PRELIMINARY OVERALLL AREA DEVELOPMENT PLAN

PECAN VALLEY ESTATES

POADP

FILE NO. 84-18-56-62
(To be assigned by the Planning Dept.

Sheet 2
PECAN VALLEY ESTATES POADP
Of 2

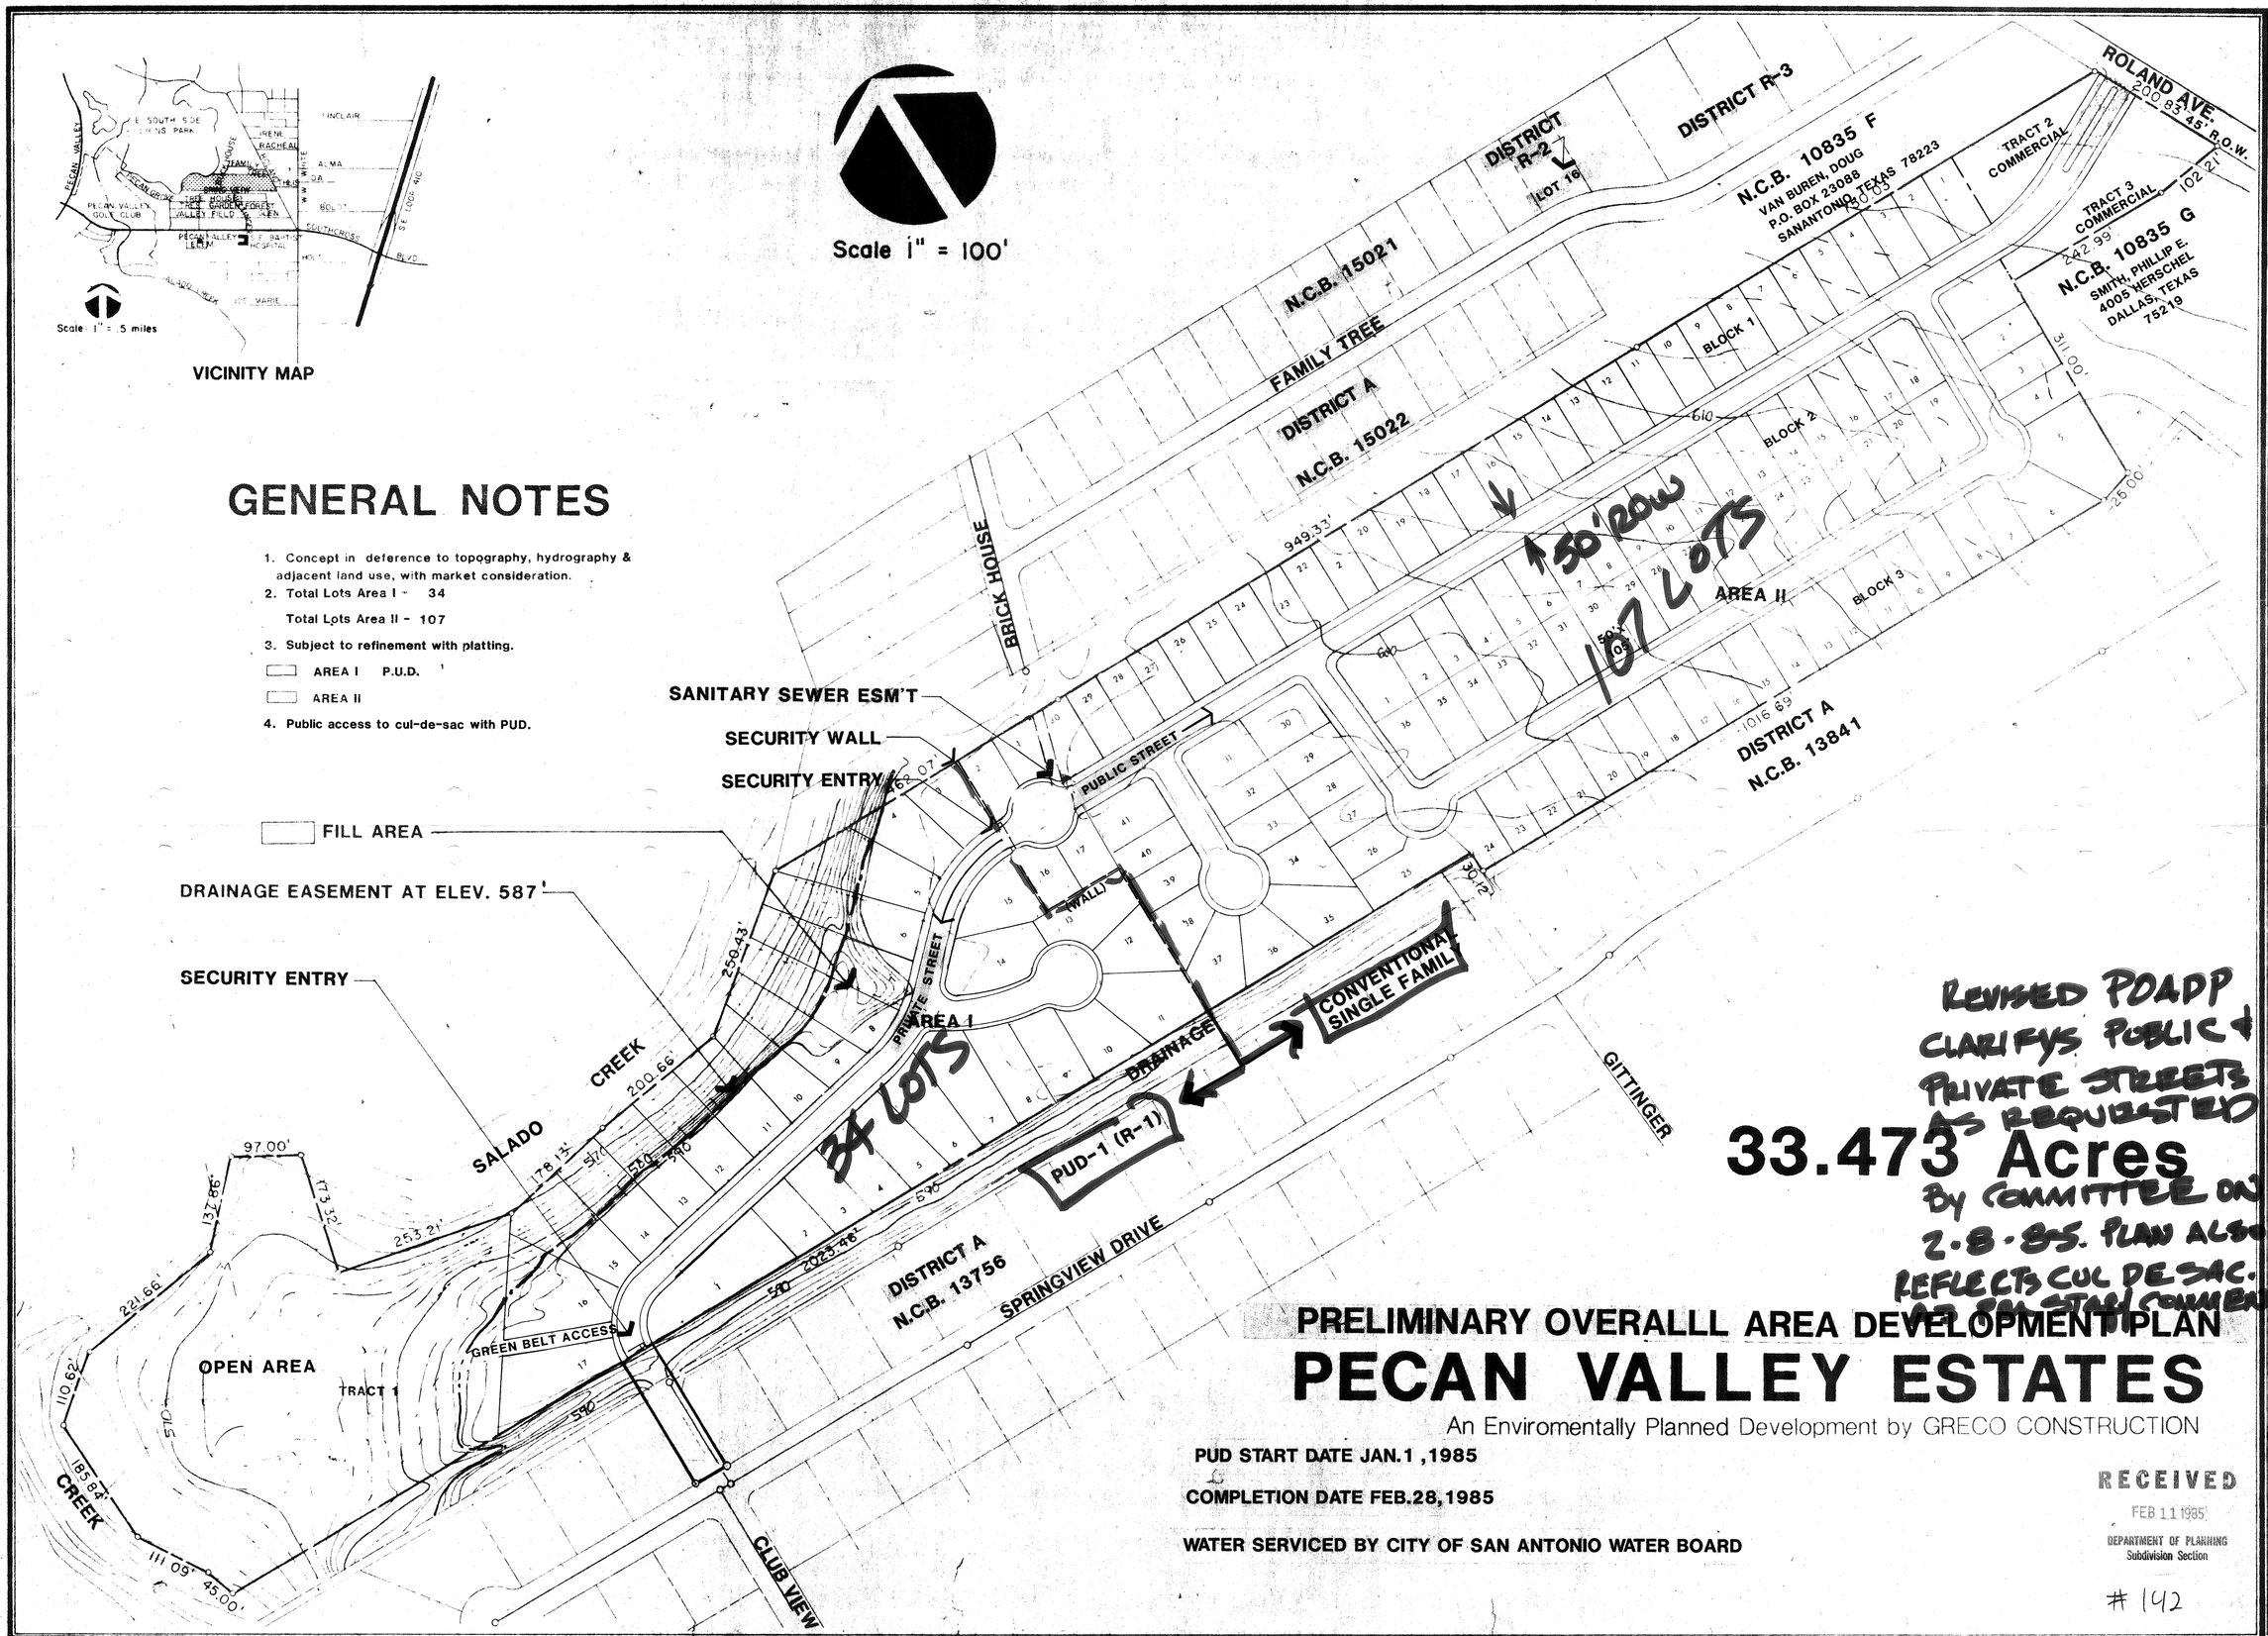
COMMENTS: Received all required info on 12-11-84
Committee reviewed 12-14-84 It was recommended that Springview be designated as a public street in entirety or that a cul de sac be provided were the public st. terminates.
11-14-84
Requested additional info from Dannay

It is recommended that the proposed street linking Roland Avenue and Springview Drive be designated as a public street or provide a cul-de-sac turnaround were your planned public street terminates.

(X) Comments: It is recommended that the proposed street linking Roland Ave. & Spring view Dr. be designated as a public street in its entirety. Staff believes it is essential, in this instance, to have direct access into the property from Spring view Dr. or Roland Ave at all times.

REVISED POADP CLARIFYS PUBLIC & PRIVATE STREETS AS REQUESTED BY COMMITTEE ON 2-8-85. PLAN ALSO REFLECTS CUL DE SAC. AS PER STAFF COMMENTS

(x) Comments: This acknowledges receipt ofthe revised POADP reflecting the cul-de-sac turn around as per staff comments dated 12-18-84. With regard to this no objection is offered.
